71-9044

GE Nuclear Energy

February 5, 1991

Reference: Certificate of Compliance No. 9044, Docket 71-9044

166D8032

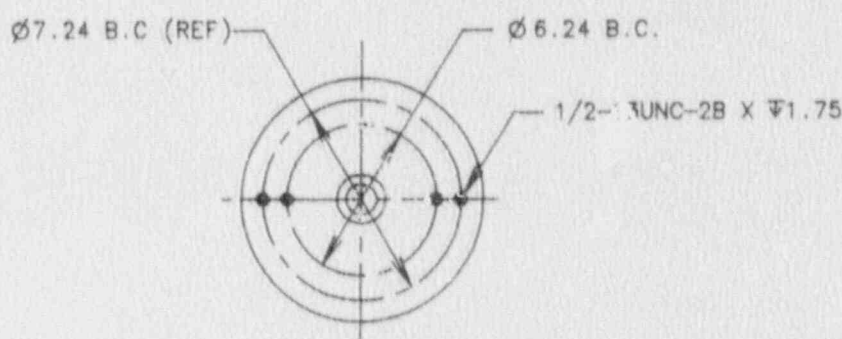
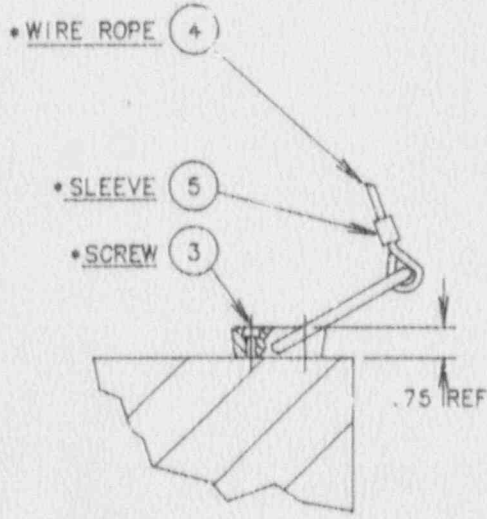
Occasionally, it will be necessary to ship irradiated hardware which, while within the 600-watt heat load limit, will require additional shielding to meet the DOT external dose rate requirements. To provide this shielding, VNC proposes the use of an inner steel liner for the Model 1600 shipping container. The liner will be fabricated as follows:

Material: 10-inch-diameter carbon steel rod approximately 53 inches in length.

Cavity: 1-1/4-inch cavity drilled down the center axis of the rod. The cavity will run the length of the rod.

Weight: Maximum 1,200 lb. (within the weight limits of Certificate of Compliance No. 9044).

The liner is shown on Certification Drawing No. 166D8032, Rev. 0, attached.

As the height of the cask cavity is 54 inches, the length of the liner (approximately 53 inches) precludes any hardware from escaping into the cavity during normal conditions of shipment. Shoring will be provided as required by Certificate of Compliance No. 9044. The form of the shoring is not specified as the location of the liner in the cask cavity is immaterial (see dose rate analysis below).

The liner will be provided with a lifting device to permit its insertion and removal from the cask. This device has not been classified as safety related as: (1) it will be used only for insertion/removal of the liner prior to and after shipment and serves no function during transport, and (2) it cannot be used to lift other components of the packaging.

The above calculations demonstrate that as long as the contents of the liner do not exceed 23,000 Ci of Co-60 or equivalent, all maximum permitted dose rates will be met. (Note: Because of the small diameter of the liner cavity, the lack of the 10 inches of steel at the top and bottom of the liner poses no problem. Dose rates at the package surface will be approximately

25% of those at the side. All shipments will be measured for radiation levels prior to shipment.) Therefore, General Electric requests that Certificate of Compliance No. 9044 be modified to permit the use of the inner liner shown on Certification Drawing No. 166D8032, Rev. 0 when necessary, to provide additional shielding for shipments of nonfissile irradiated metal hardware with a content not exceeding 20,000 Ci of Co-60 or its equivalent.

GENERAL ELECTRIC  
 129D4735  
 MODEL 1600 TRANSPORT CONTAINER  
 CERTIFICATION DWG.

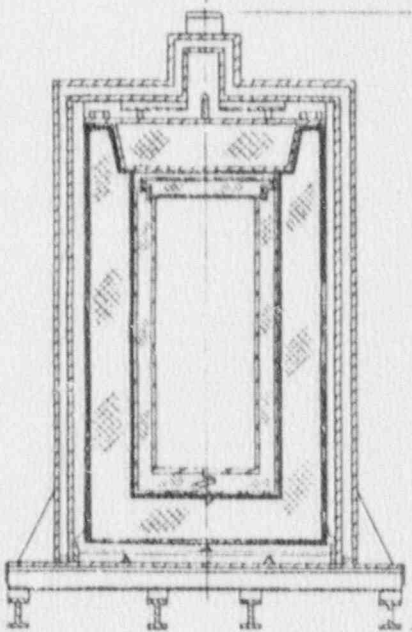
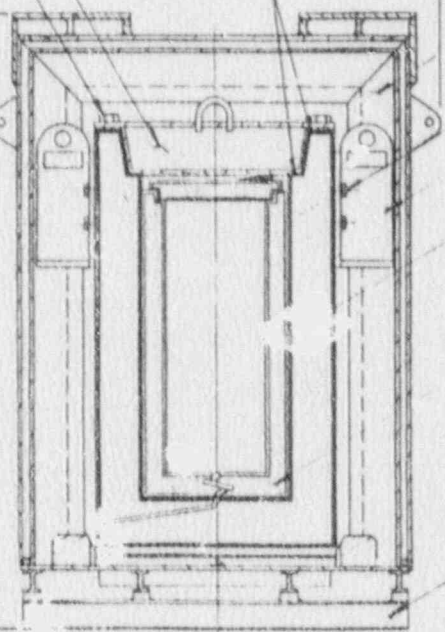
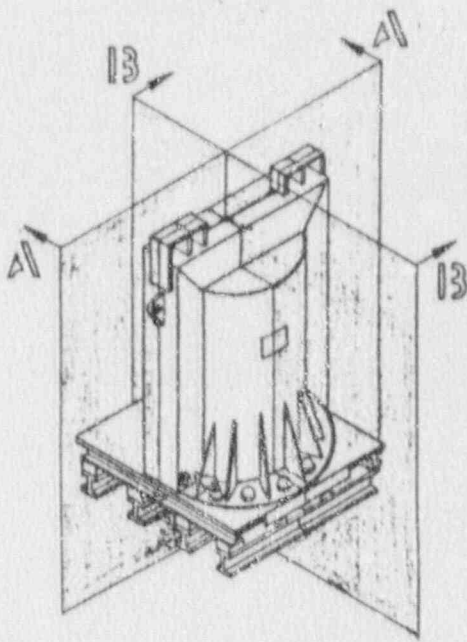
Section 5.(a)(3) of Certificate of Compliance No. 9044 lists an exception to Drawing No. 129D4735, Rev. 4 concerning the length of fastening bolts. GE is including in this submittal a revised drawing No. 129D4735, Rev. 5, which corrects the drawing to conform with the Certificate. It also includes a reference for the new steel liner.
